Submission by Washington DC Ward Two and Three to the FAA for
Modifications to the Proposed LAZIR B Departure Procedure (Revised)

November 1, 2016

Current, Proposed, & DC Proposal

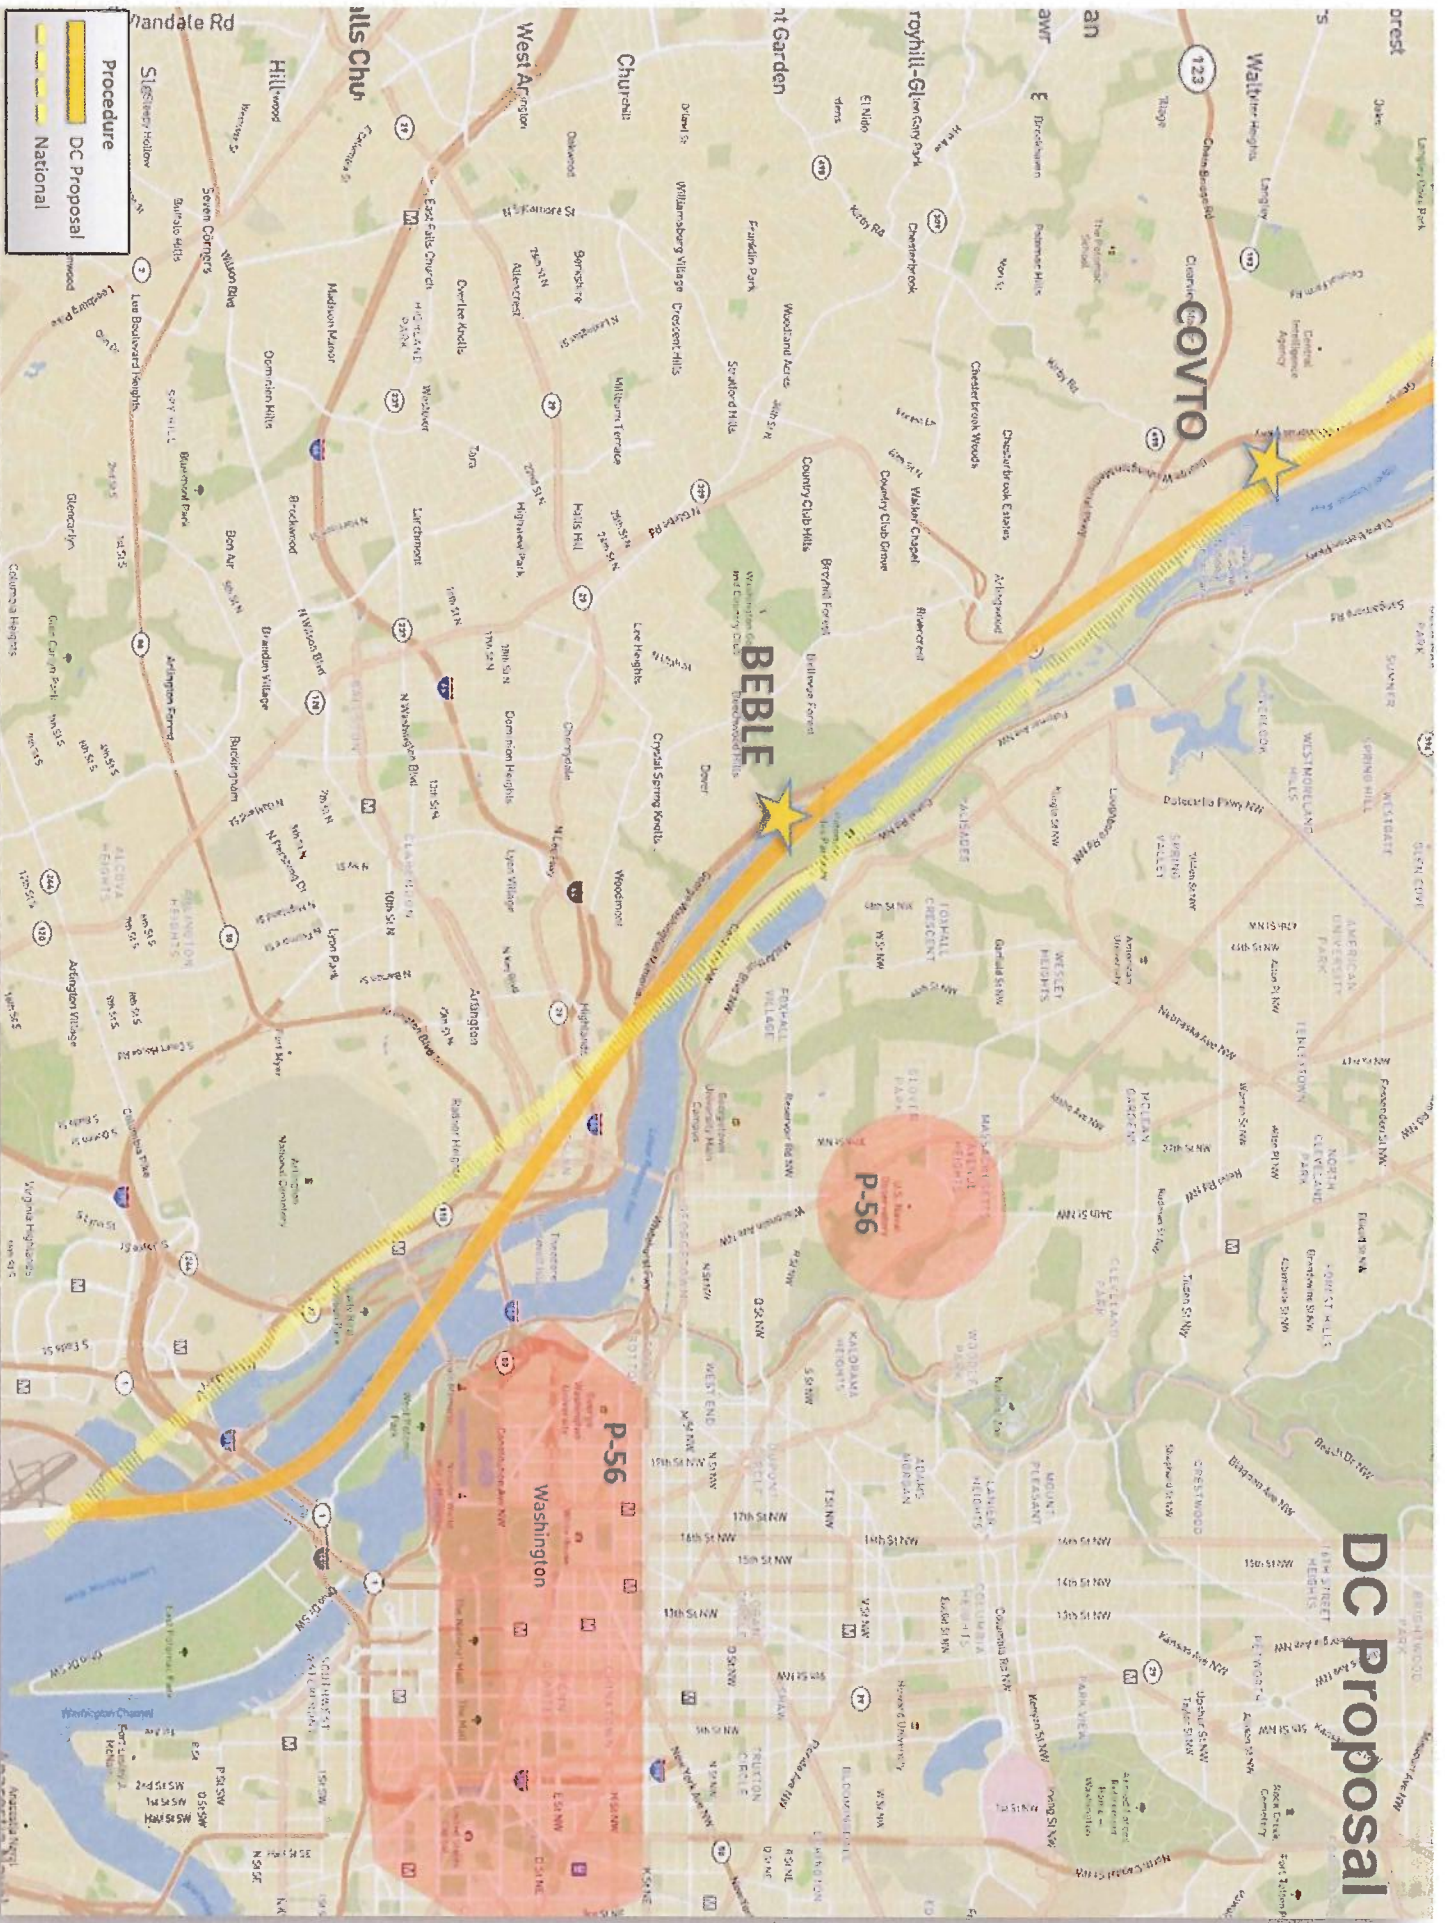
We therefore propose two adjustments to the LAZIR B departure procedure. First instead of bringing planes over the river extremely close to the Prohibited Zone (P-56) and then over Georgetown we propose that that the first waypoint named ADAXE be eliminated and that aircraft make their way to BEBLE as the first point. The location of BEBLE would be the same as proposed in LAZIR B close to the Georgetown Reservoir. The next waypoint COVTO would use the current location of COVTO instead of moving it east as proposed in LAZIR B. This combination of new and old waypoints would require planes after takeoff to make a sharp turn to the west and head in a straight line to BEBLE. At our request the FAA confirmed that such a flight path was flyable and provided us with the attached schematic of this flight path (in orange) compared with the NATIONAL 328 in yellow.

First, the current LAZIR flight path follows a figure S pattern which increases aircraft noise because of the turns at ADXE and BEBLE. The proposed modification of LAZIR B would create a straighter flight path similar to the NATIONAL 328 which should decrease aircraft noise on both sides of the river.

Second, planes can climb faster when flying in a straight line as opposed to constantly turning so the proposed flight path would facilitate planes gaining altitude sooner which also impacts the amount of aircraft noise on the ground. Straight line flight also uses less fuel and produces less pollution both of which are goals of the Next Gen Act which the FAA is supposed to consider in designing flight paths.

Finally, the proposed modification of LAZIR B moves the flight path further away from P-56, which includes the White House and the National Monuments on the Mall, which are currently being subjected to significant aircraft noise and pollution as planes turn left approaching ADAXE.
